World Forum for Harmonization of Vehicle Regulations

Proposal for the 03 series of amendments to Regulation No. 95 (Lateral collision protection)

Submitted by the Working Party on Passive Safety *

Model B

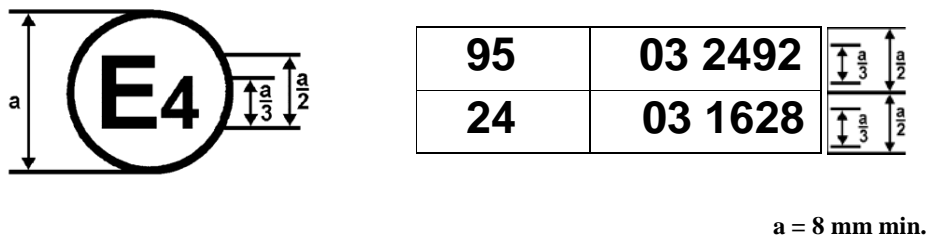
The above approval mark affixed to a vehicle shows that the vehicle type concerned has been approved in the Netherlands (E4) pursuant to Regulations Nos. 95 and 24.¹ The first two digits of the approval numbers indicate that, at the dates when the respective approvals were granted, Regulation No. 95 incorporated the 03 series of amendments and Regulation No. 24 incorporated the 03 series of amendments.”
